## SERVICE BULLETIN

**APPLICABILITY:** 2013-16MY BRZ

**NUMBER:** 09-54-12R

**SUBJECT:** High-Pitched “Chirp,” “Squeak” or “Cricket”  
 Sound from the Engine

**PUMP DRIVE CASE ASSEMBLY (Check Table Above for Applicability)**

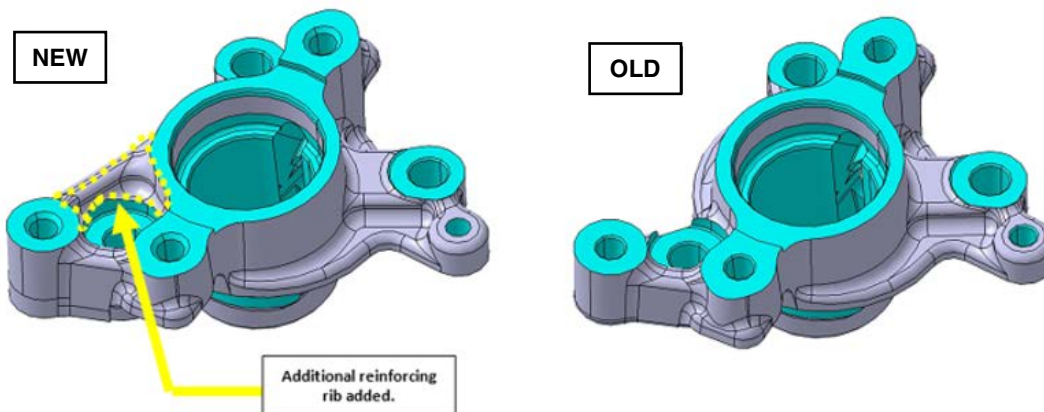
VIN RANGE	REQUIRED PART REPLACEMENT(S)		
	DI Fuel Pump	Drive Case	Rocker Cover LH
Prior to F*603025	YES	YES	YES
F*603026 to F*603363	YES	NO	YES
F*603364 to G*604648	YES	NO	NO
